ADDENDUM NO. 2

**MSHP Interoperability Site,
Replace Roof & Renovate Basement and Access,
Support Services Bldg.,
2413 East McCarty St.,
Jefferson City, MO 65101
PROJECT NO. R2508-01**

Bidders are hereby informed that the Construction Plans and/or Specifications are modified as follows:

SHEET TITLE:
DEMOLITION &
SITE PLAN
WEST STAIR
TOWER

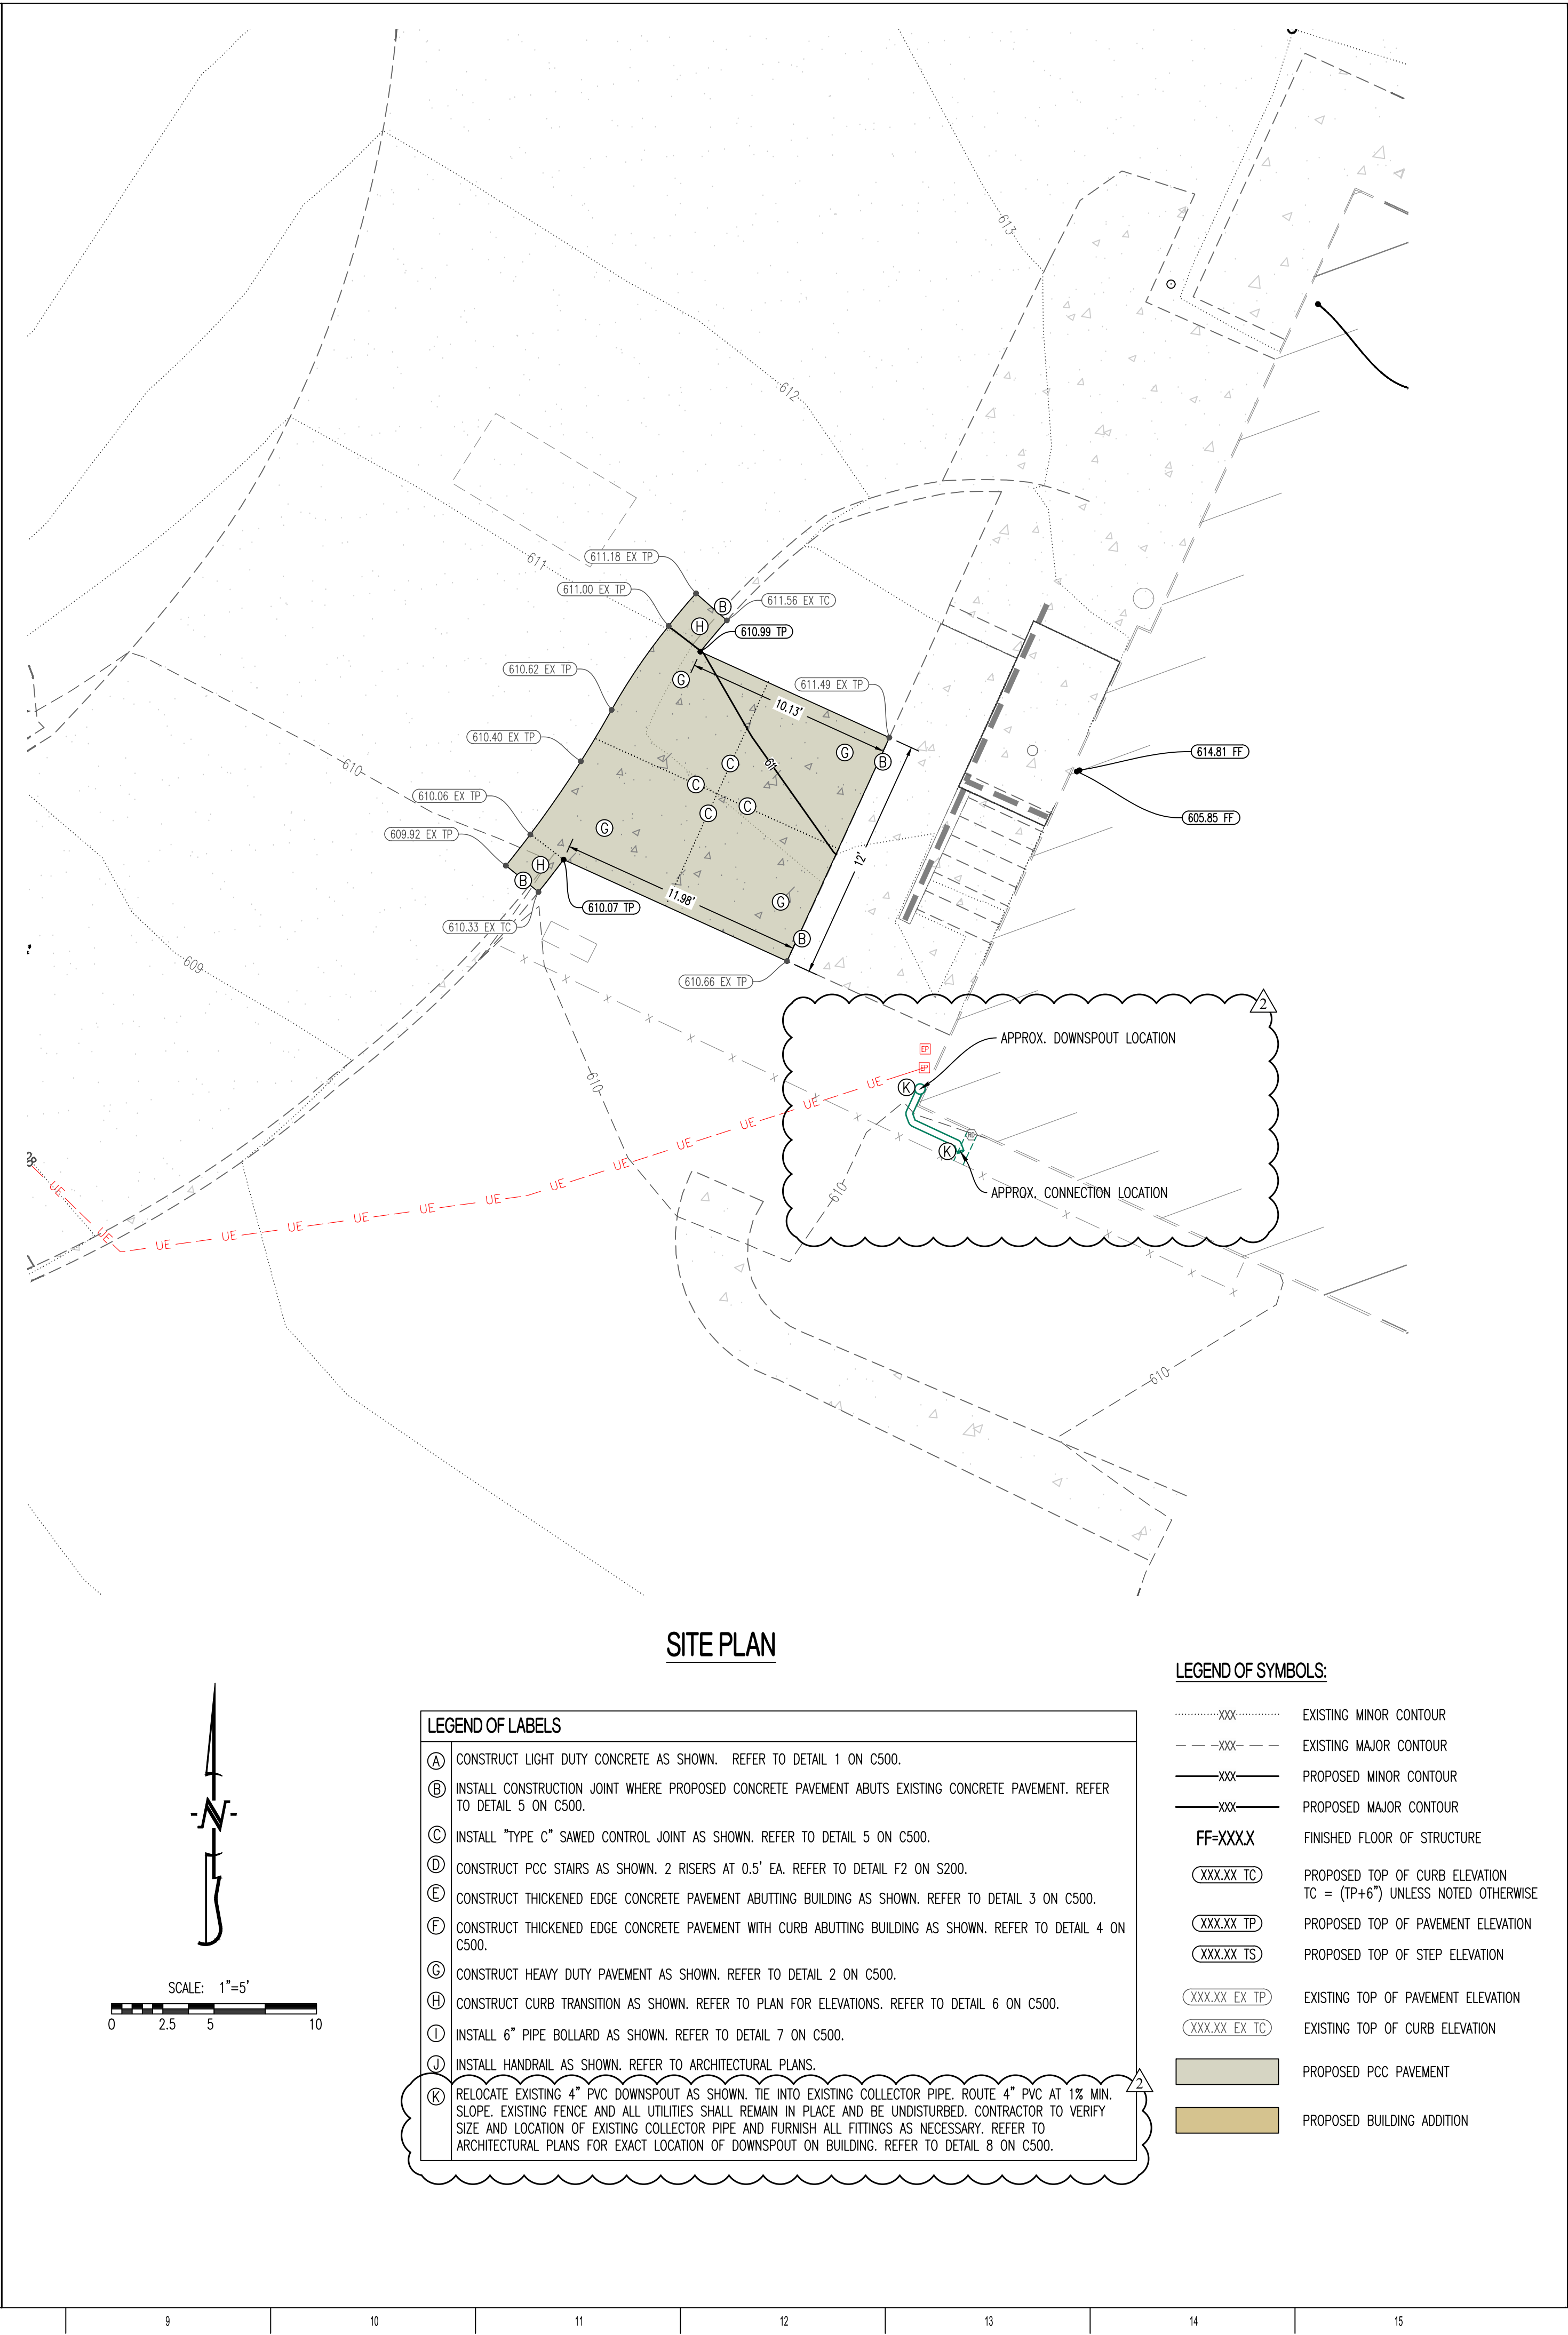
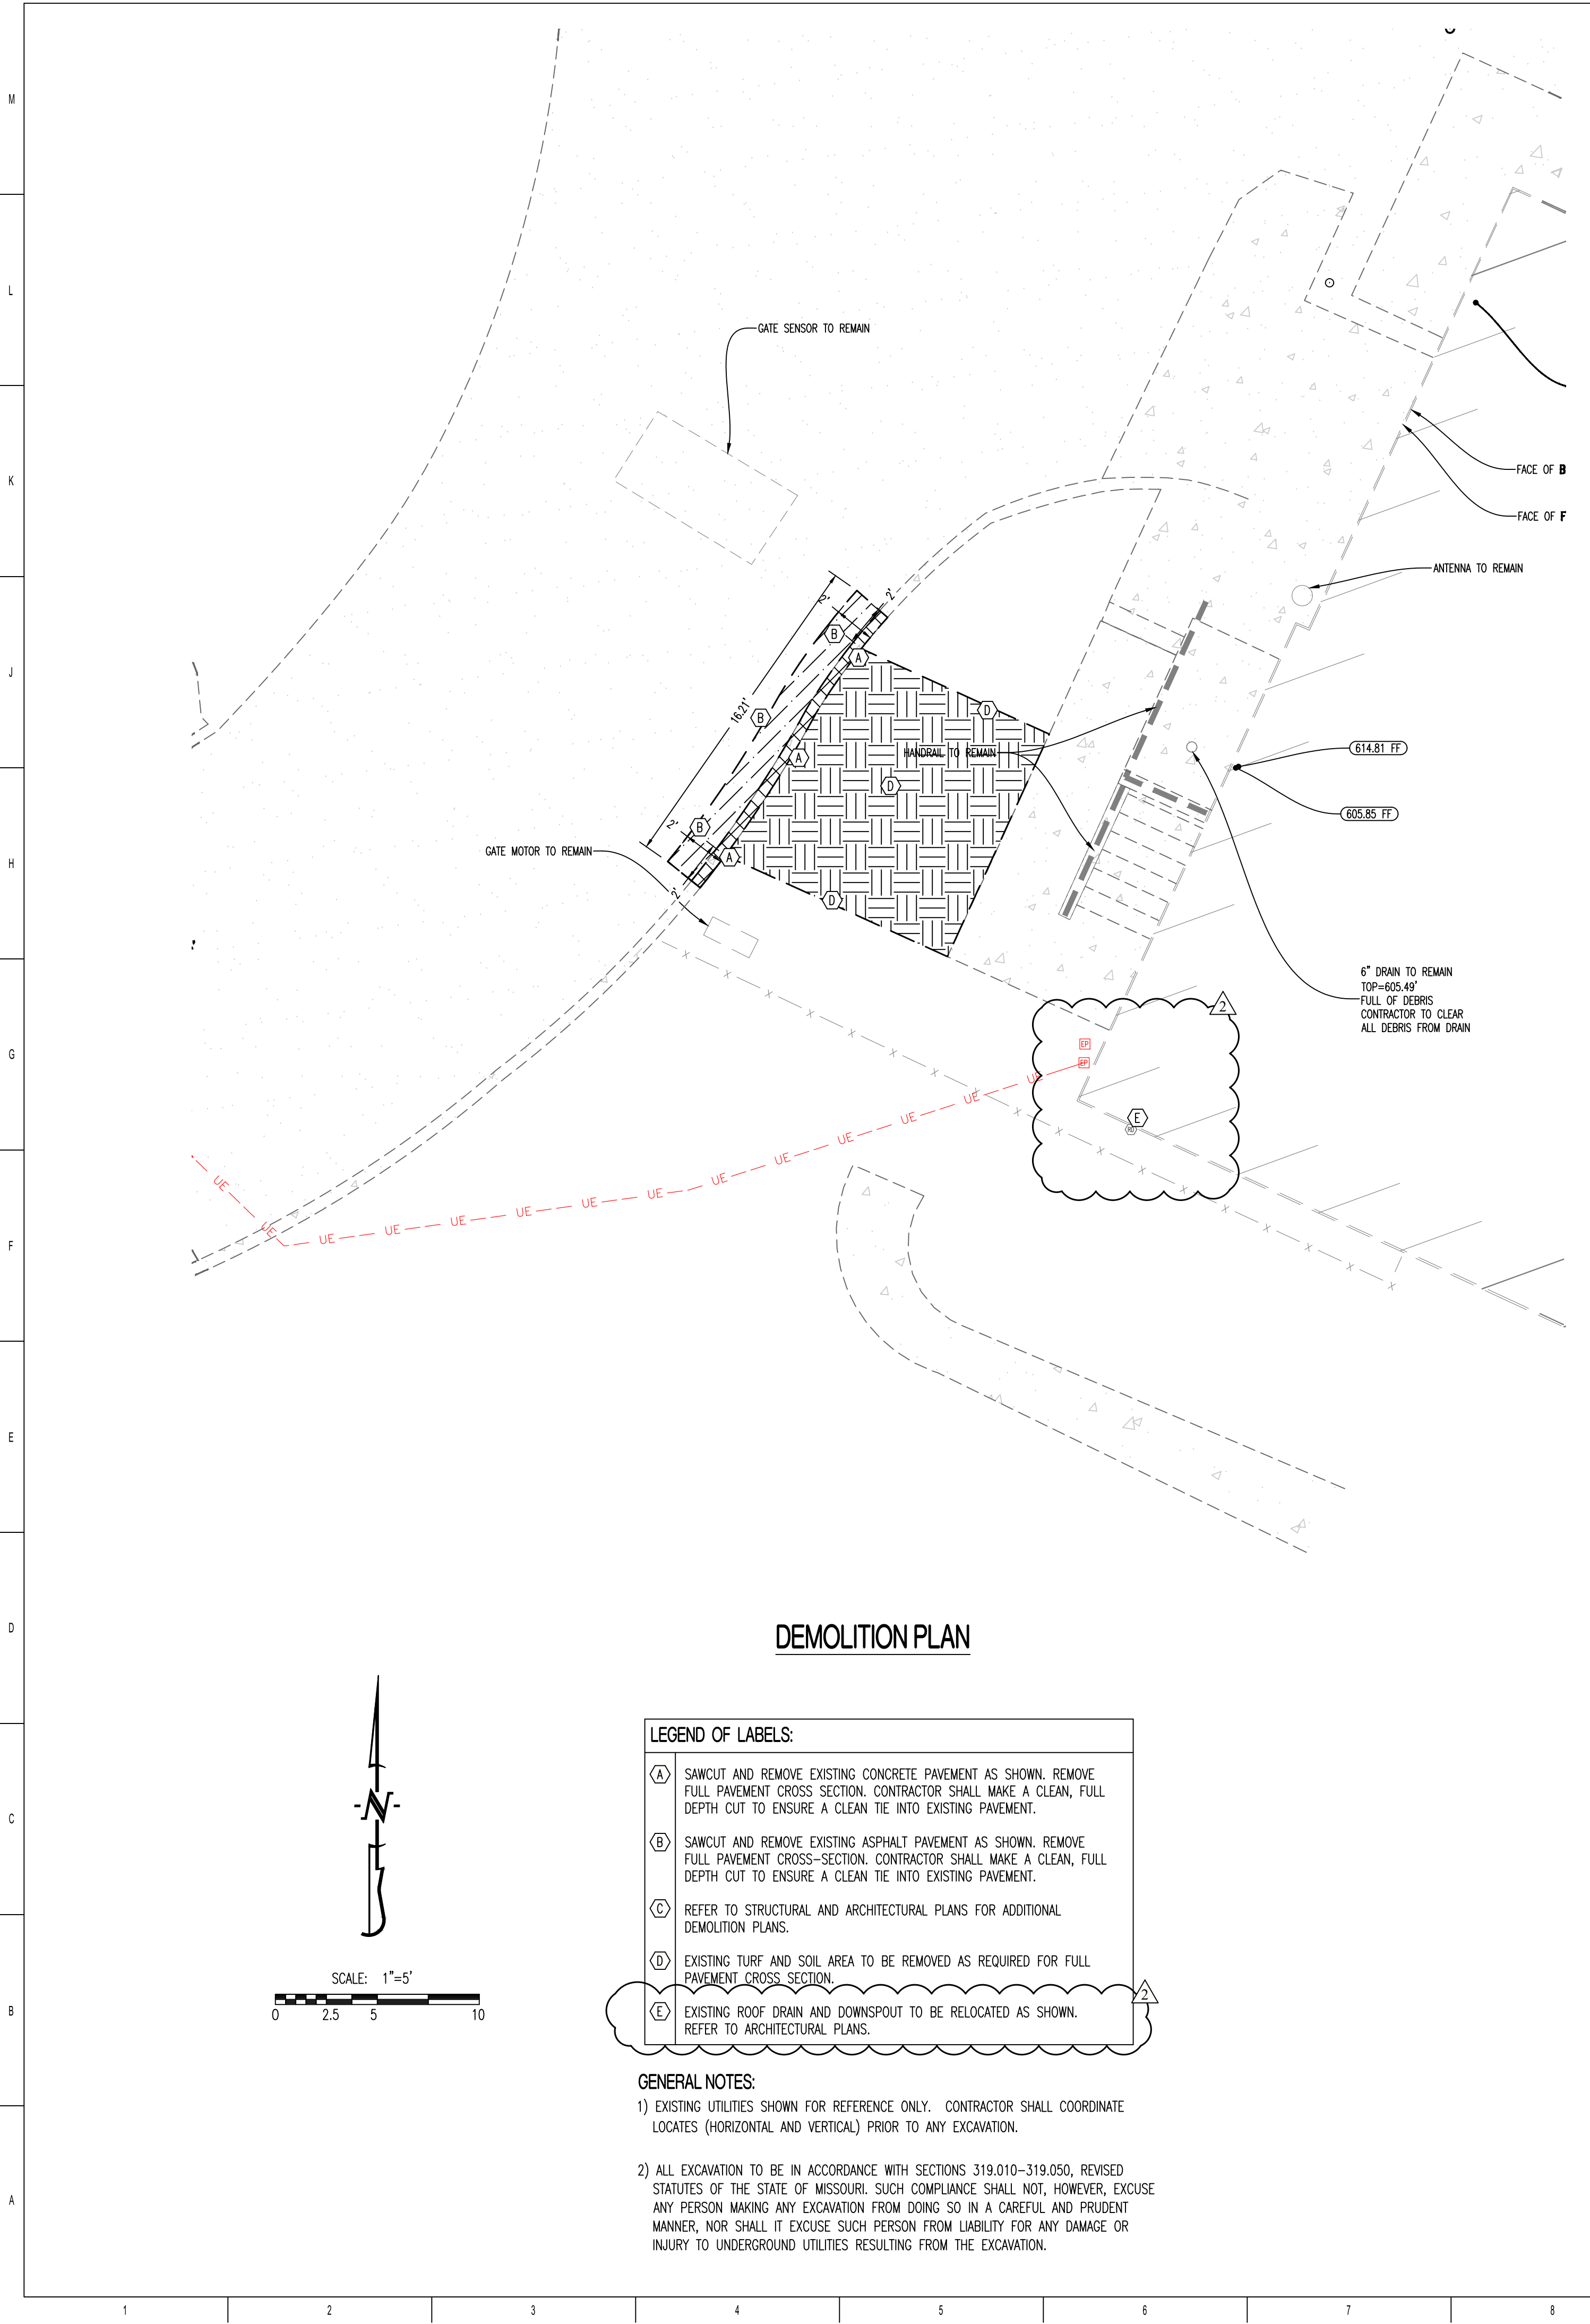
1. *SHEET C101*
 - a. ADD Note "E" to demolition plan.
 - b. ADD Note "K" to site plan.
2. *SHEET C101.1 – ADDED AS A NEW SHEET*
3. *SHEET C500*
 - a. ADD Detail 8 – Roof drain detail.
